**SAN LEANDRO SENIOR CENTER - PHASE 2  
PROJECT NO. 06-210-18-116**

**ADDENDUM NO. 3**

July 16, 2008

ADD-3  
REVISION  
AD3-9/C5.0-02  
DRAWING

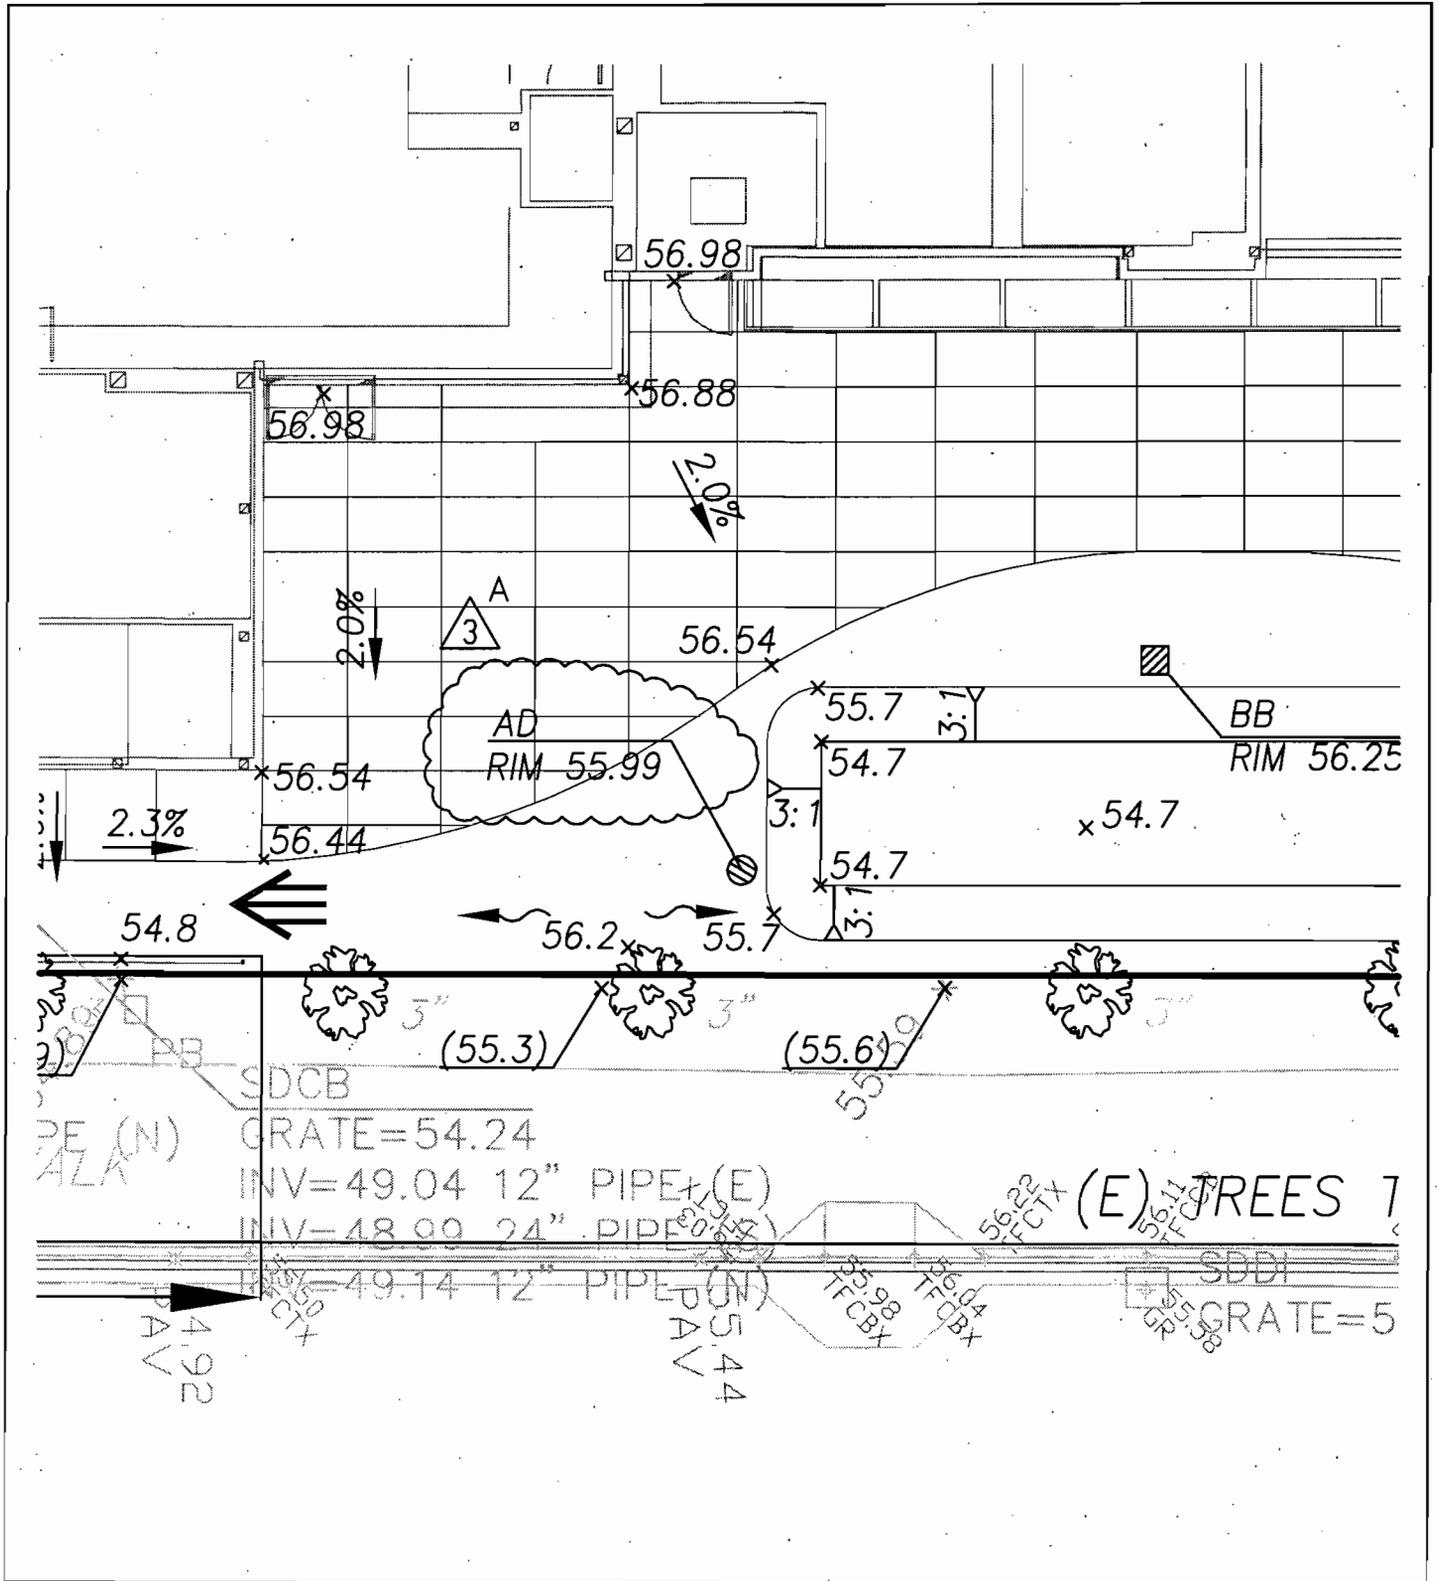
- D-2. Sheet C5.0 Grading Plan:  
Sketch AD3-9/C5.0-02: REVISE note for Asphalt Concrete.
- D-3. Sheet C5.0 and C5.2 Grading Plan:  
Sketch AD3-1/C5.0-01 and AD3-2/C5.2-01: REVISE bio-retention basin overflow drain elevation.

ADDENDUM 3  
REVISION  
AD3/L0.1-01  
DRAWING

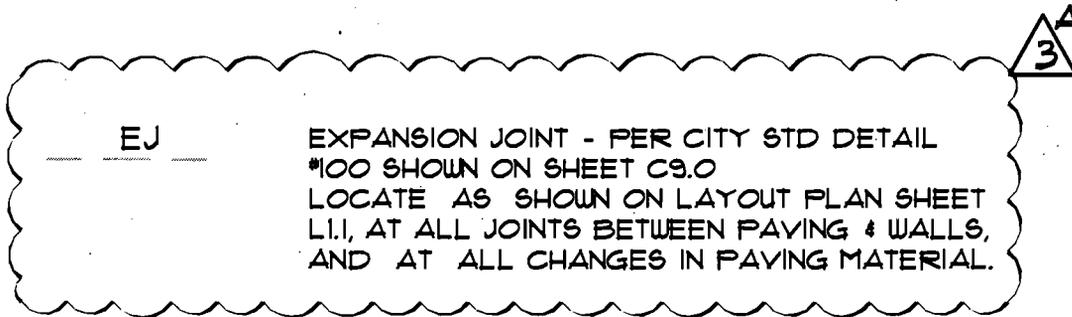
- D-6. Sheet C9.0 Details:  
Sketch AD3-10/C9.0-01: REVISE City Standard detail 100 - Curb and Gutter Detail.
- D-7. Sheet L0.1. Notes & Legend:  
Sketch AD3/L0.1-01: In the Layout Legend, REVISE Expansion Joint note to read as follows: EJ: Expansion Joint – Per City Standard Detail #100 shown on Sheet C9.0. Locate as shown on Layout Plan Sheet L1.1, at all joints between paving and walls, and all changes in the paving materials.

EJ EXPANSION JOINT - PER CITY STD DETAIL  
#100 SHOWN ON SHEET C9.0  
LOCATE AS SHOWN ON LAYOUT PLAN SHEET  
L1.1, AT ALL JOINTS BETWEEN PAVING & WALLS,  
AND AT ALL CHANGES IN PAVING MATERIAL.

ADDENDUM 3  
 REVISION  
 AD3/L1.1-01  
 DRAWING

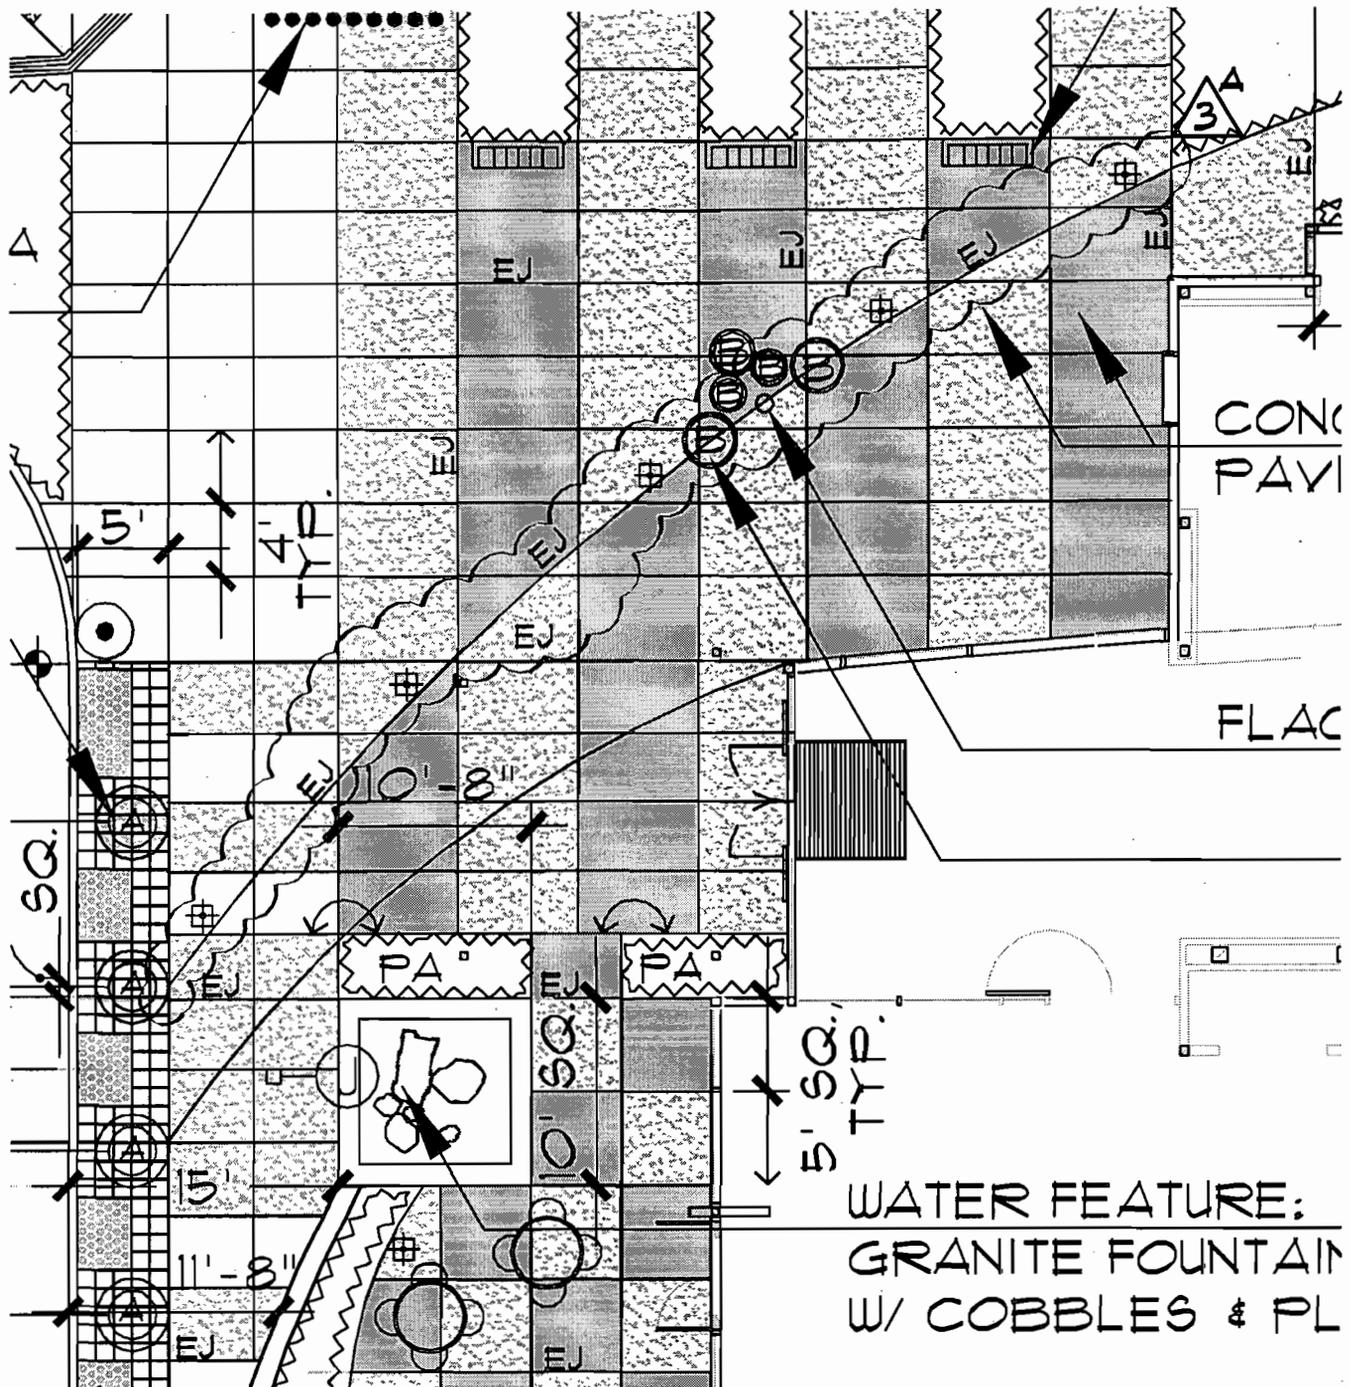
- D-8. Sheet L1.1. Layout Plan:  
Sketch AD3/L1.1-01: ADD expansion joint at the longer arc at the entry plaza as indicated.
- D-9. Sheet A2.2A Partial Composite Clerestory Plan:  
Sketch AD3-1/A2.2A-01: ADD key note 12 “Exterior Roof Ladder, see A8.14” and revise callout.

ADDENDUM 3  
 REVISION  
 AD3-1/A2.2A-01  
 DRAWING

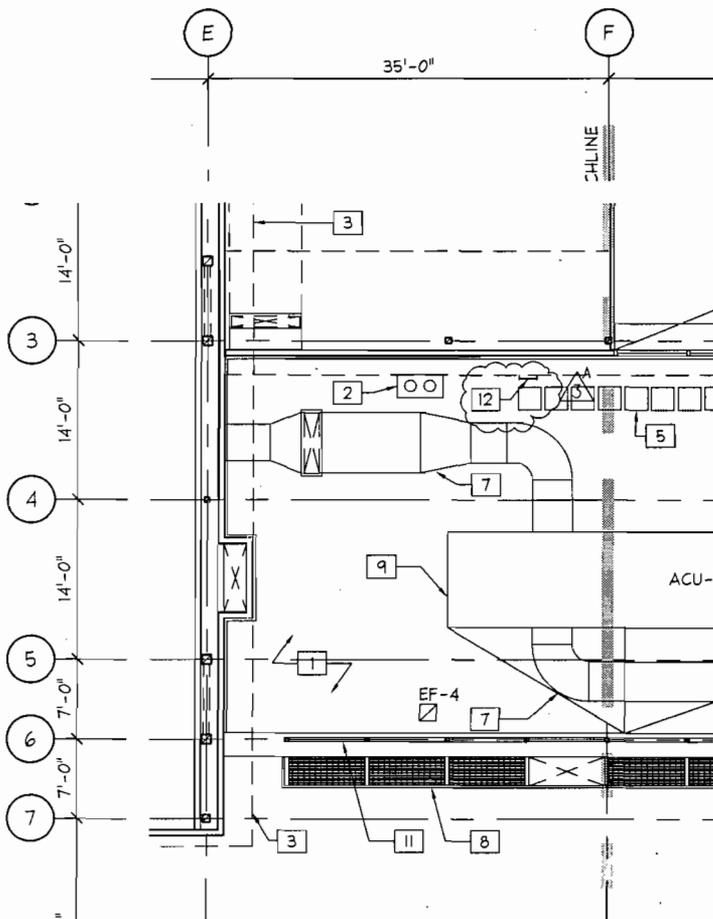
- Q-10. A2.2A – Note 6 points to a ladder symbol. Clarify if ladder is needed here.  
Response: See Drawing Change D-9 and D-10 of this Addendum.
- Q-11. Section 05521 Pipe and Tube Railings, paragraph 2.7.F.2 Interior Railing. Confirm if “Commercial Blast Cleaning” is necessary?

ADDENDUM 3  
 REVISION  
 AD3-1/A2.3A-01  
 DRAWING

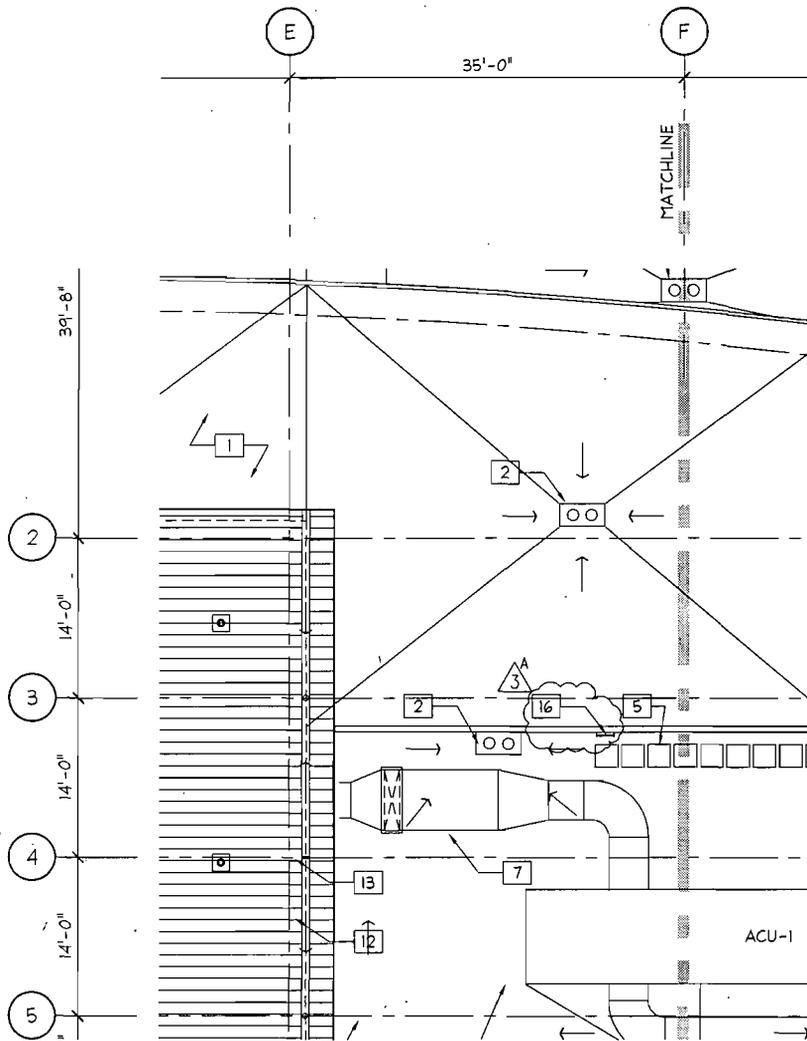
- D-10. Sheet A2.3A Partial Composite Clerestory Plan:  
Sketch AD3-1/A2.3A-01: ADD key note 16 “Exterior Roof Ladder, see A8.14” and revise callout.
- D-11. Sheet A2.8 Window Schedule:  
ADD (3) Manual Shades (MS) for window 11, 15 and 19. Shade box to be wall mounted, flush with ceiling. No sketch issued.

ADDENDUM 3  
REVISION  
AD3-1/A2.9-01  
DRAWING

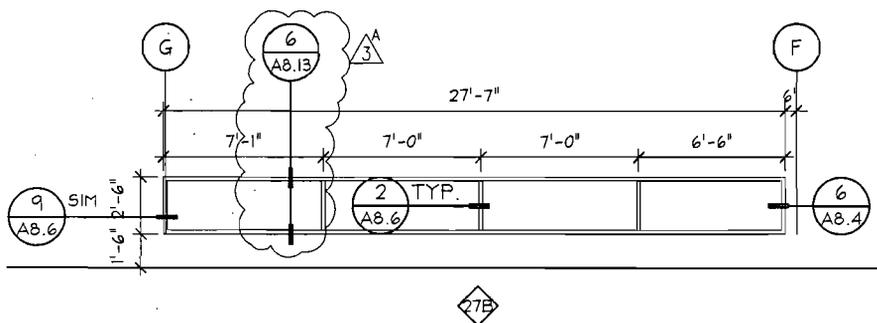
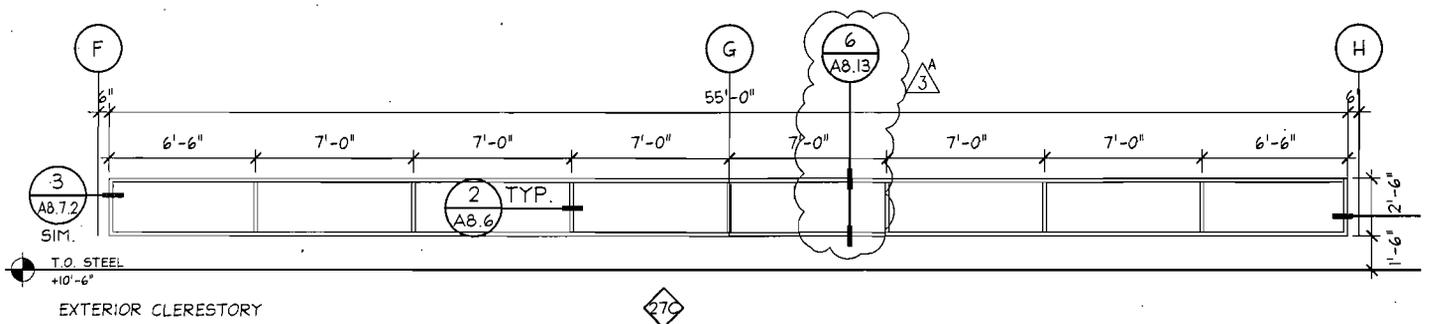
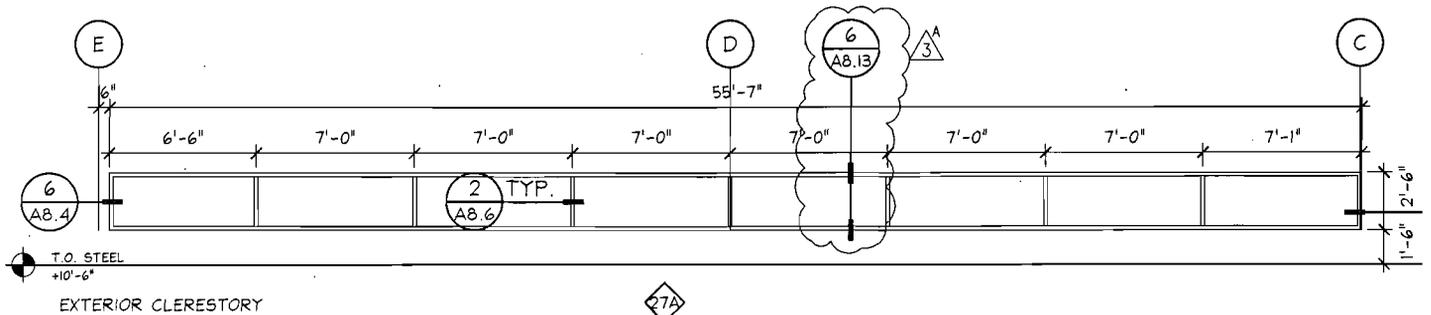
- D-12. Sheet A2.9 Window Schedule:  
Sketch AD3-1/A2.9-01: ADD detail callout for windows 27A, 27B and 27C.
- D-13. Sheet A4.1 Enlarged Floor Plans:  
Sketch AD3-2/A4.1-01: REVISE to include casework on west wall as indicated on interior elevation.

ADDENDUM 3  
 REVISION  
 AD3-2/A4.1-01  
 DRAWING

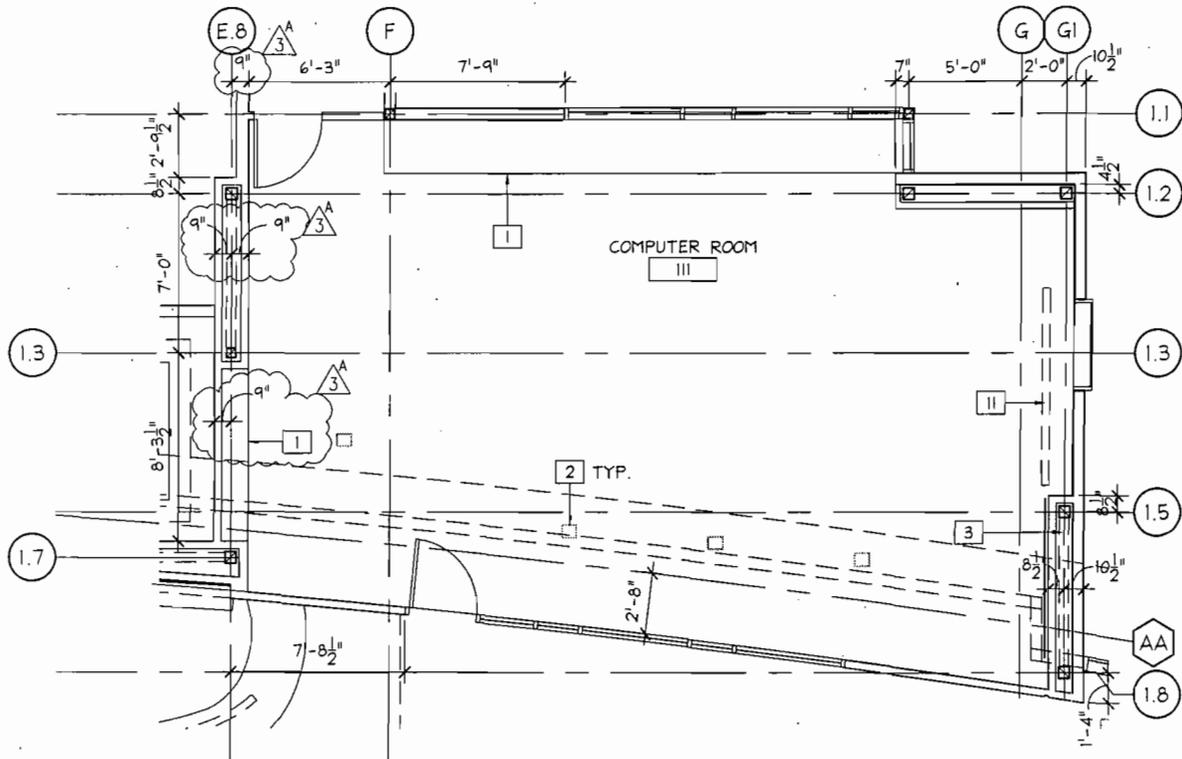
Q-29. Computer Room 111: Not clear if casework occurs on at west wall? Elevation detail 2/A5.6 show casework in hidden line with reference detail 3/A9.10, however casework is not drawn on floor plan A2.1B. For bidding purpose, is it acceptable to assume plastic laminate?

Response: Casework shown in detail 2/A5.6 is part of contract. Detail 2/A4.1 has been revised, see Drawing Change D-13 of this Addendum. See 3/A9.10 for section cut reference for material and construction.
